SUBJECT: ST. LUCIE UNIT 1 - ISSUANCE OF AMENDMENT RE: PRESSURE/TEMPERATURE
(P/T) LIMITS AND LOW TEMPERATURE OVERPRESSURE PROTECTION (LTOP)
ANALYSIS (TAC NO. 75386)

Amendment No. 104
License No. DPR-67

ATTACHMENT TO LICENSE AMENDMENT NO. 104
TO FACILITY OPERATING LICENSE NO. DPR-67
DOCKET NO. 50-335

SAFETY EVALUATION BY THE OFFICE OF NUCLEAR REACTOR REGULATION

FIGURE 3.1-1b
MAXIMUM ALLOWABLE HEATUP AND COOLDOWN RATES,
SINGLE HPSI PUMP IN OPERATION

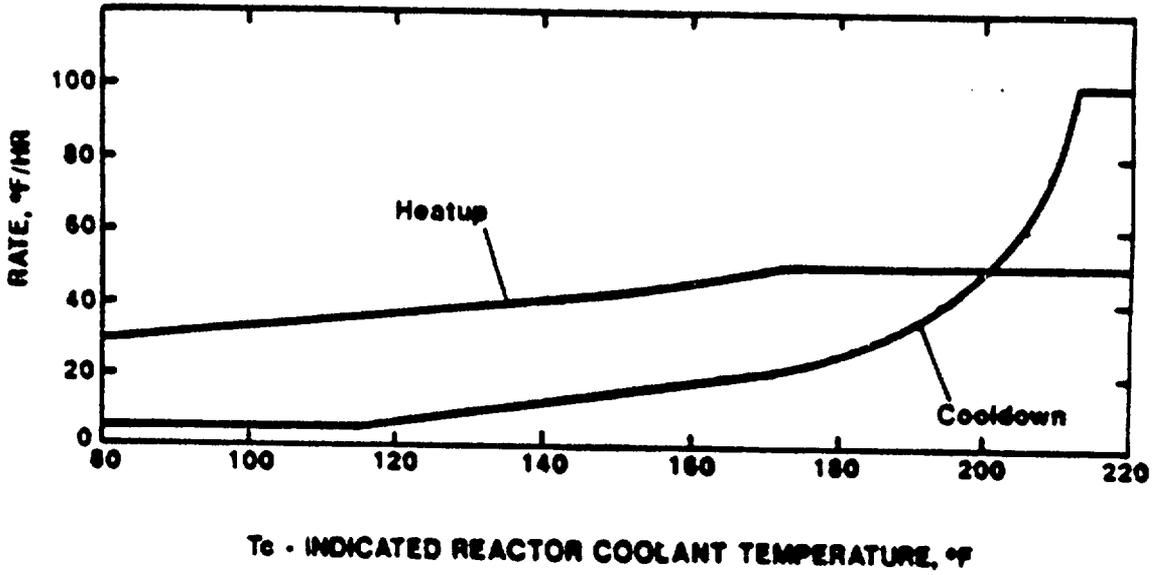
*The flow path from the RWT to the RCS via a single HPSI pump shall only be established if: (a) the RCS pressure boundary does not exist, or (b) no charging pumps are operable. In this case all charging pumps shall be disabled, and heatup and cooldown rates shall be limited in accordance with Fig. 3.1-1b.

*When the flow path from the RWT to the RCS via a single HPSI pump is established per 3.1.2.3, the heatup and cooldown rates shall be established in accordance with Fig. 3.1-1b.

FIGURE 3.4-2a
 ST. LUCIE UNIT 1 P/T LIMITS, 15 EPPY
 HEATUP AND CORE CRITICAL

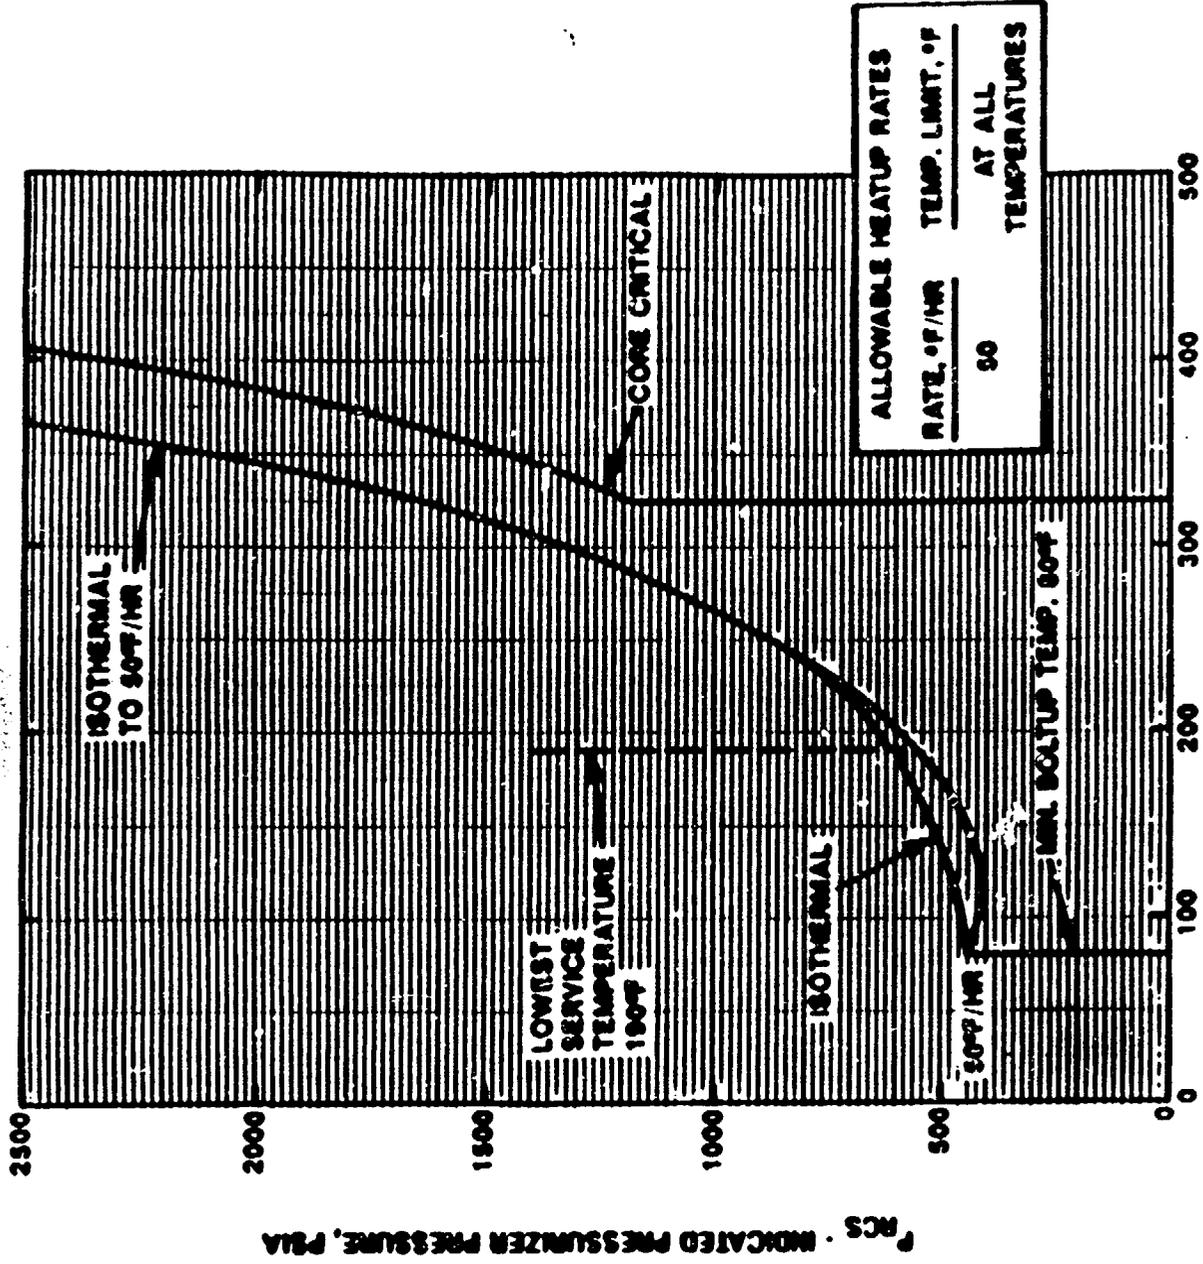
The heatup and cooldown limit curves (Figures 3.4-2a and 3.4-2b) are composite curves which were prepared by determining the most conservative case, with either the inside or outside wall controlling, for any heatup rate of up to 50°F/hr and for any cooldown rate of up to 100°F per hour. The heatup and cooldown curves were prepared based upon the most limiting value of the predicted adjusted reference temperature at the end of the applicable service period.

The pressure-temperature limit lines shown on Figures 3.4-2a and 3.4-2b for reactor criticality and for inservice leak and hydrostatic testing have been provided to assure compliance with the minimum temperature requirements for Appendix G to 10 CFR 50.

By letter dated December 5, 1989, the licensee provided its updated P/T curves in proposed TS Figures 3.4-2a (for heatup and core critical) and 3.4-2b (for cooldown and inservice testing), changes in the values of the RCS cold leg temperature at which LTOP should be enabled, and the justification for the changes. The new P/T curves are based on the irradiation damage prediction methods of RG 1.99, "Radiation Embrittlement of Reactor Vessel Materials," Revision 2, U.S. Nuclear Regulatory Commission, May 1988, and are applicable for a period up to 15 EFPY. New cooldown rates as a function of indicated reactor coolant temperature are also proposed in an updated Figure 3.4-3.

The staff concludes that the proposed P/T limits for the RCS for heatup, cooldown, leak test, and criticality are valid through 15 EFPY because the limits conform to the requirements of Appendices G and H of 10 CFR Part 50. The licensee's submittal also satisfies Generic Letter 88-11 because the licensee used the method in RG 1.99, Rev. 2 to calculate the ART. Hence, the proposed P/T limits may be incorporated into the St. Lucie 1 TS.

FIGURE 3.4-20
 ST. LUCIE UNIT 1 P/T LIMITS, 18 EFPY
 COOLDOWN AND RESERVICE TEST

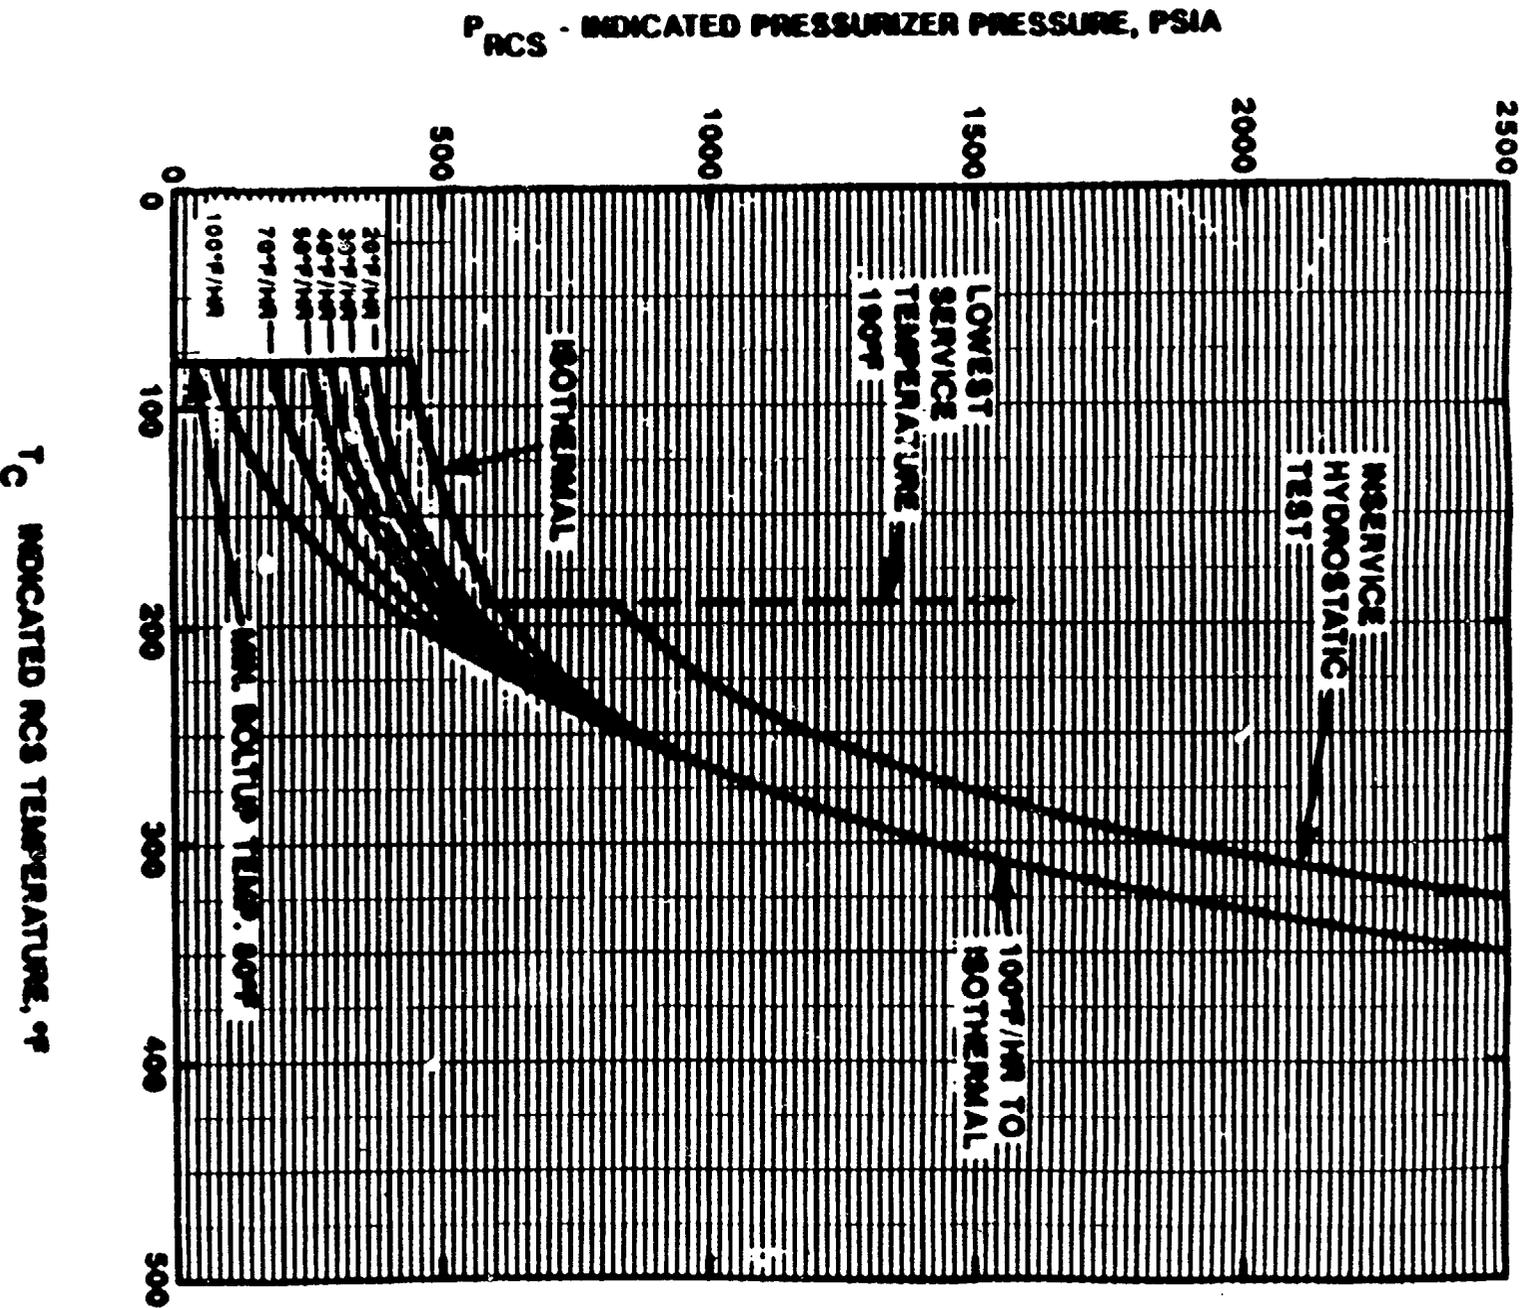
The low temperature overpressure protection system (LTOP) is designed to prevent RCS overpressurization above the 10 CFR Appendix G operating limit curves (Figures 3.4-2a and 3.4-2b) at RCS temperatures at or below 304°F during heatup and 281°F during cooldown. The LTOP system is based on the use of the pressurizer power-operated relief valves (PORVs) and the implementation of administrative and operational controls.
